**Clearfield Elementary School Renovation & Addition  
BG 21-048  
Change Order Request  
CO 300-02**

**REQUEST #:** PR #13  
**DESCRIPTION:** Floor Slab Replacement

DATE:	May 19, 2022	PR #:	13
TO:	Packs + Walker Construction Co. 75 Baldrige Road Morehead, KY 40351	RE:	Clearfield Elementary Renovations & Additions Rowan County, Kentucky BG 21-048 RTA 2037

PR#13 - FLOOR SLAB REPLACEMENT  
 CLEARFIELD ELEMENTARY SCHOOL RENOVATION & ADD.  
 FOR:  
 ROWAN COUNTY BOARD OF EDUCATION  
 460 McBrayer Road, Clearfield, Kentucky 40313

FLOOR DEMOLITION PLAN

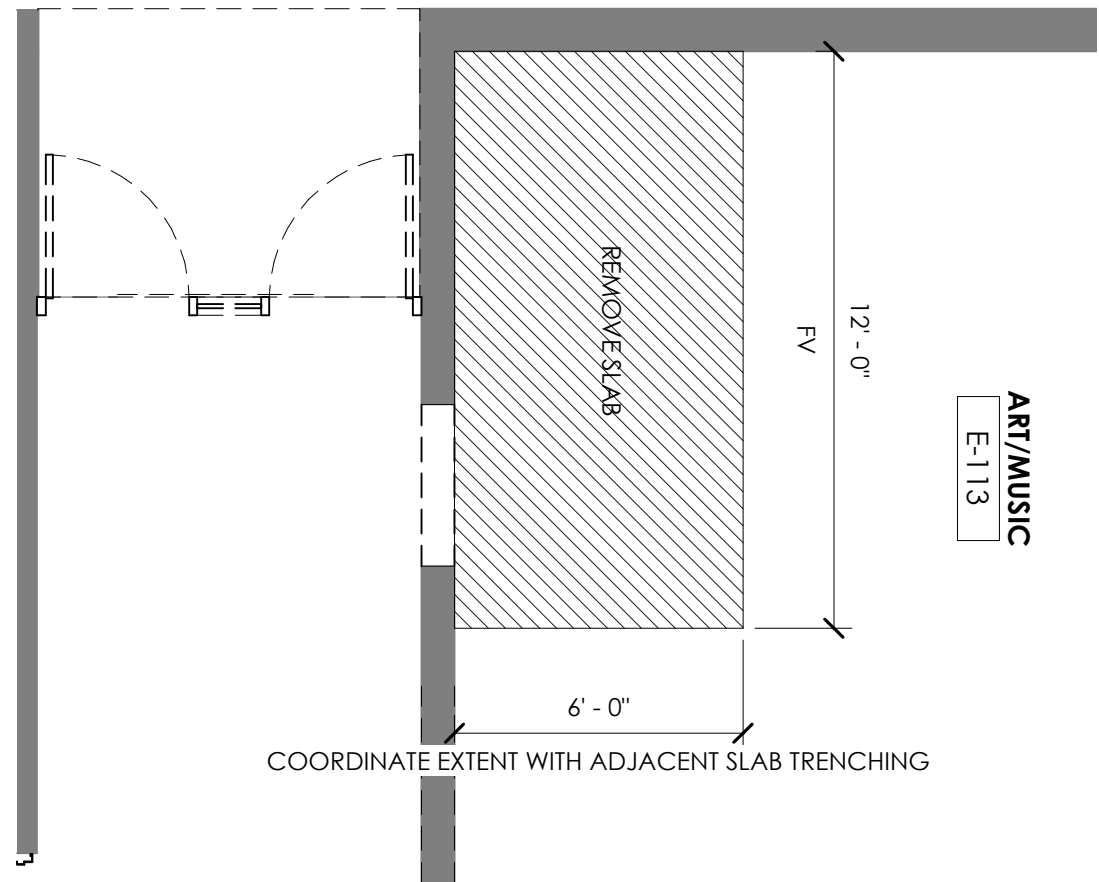
Provide a detailed pricing breakdown for all labor, material, and equipment costs associated with replacing the existing portion of concrete slab within FRC 101 to provide a new level floor condition as shown on the attached sketches.

- Extent of slab removal shall coordinate with the new door frame and the adjacent underslab trenching area indicated in RFI 40.
- Contractor to feather the new slab edge as needed to transition to the existing slab @ a 2% maximum slope. Feathering product to be comparable to a high strength cement self-leveling underlayment to achieve the transition.
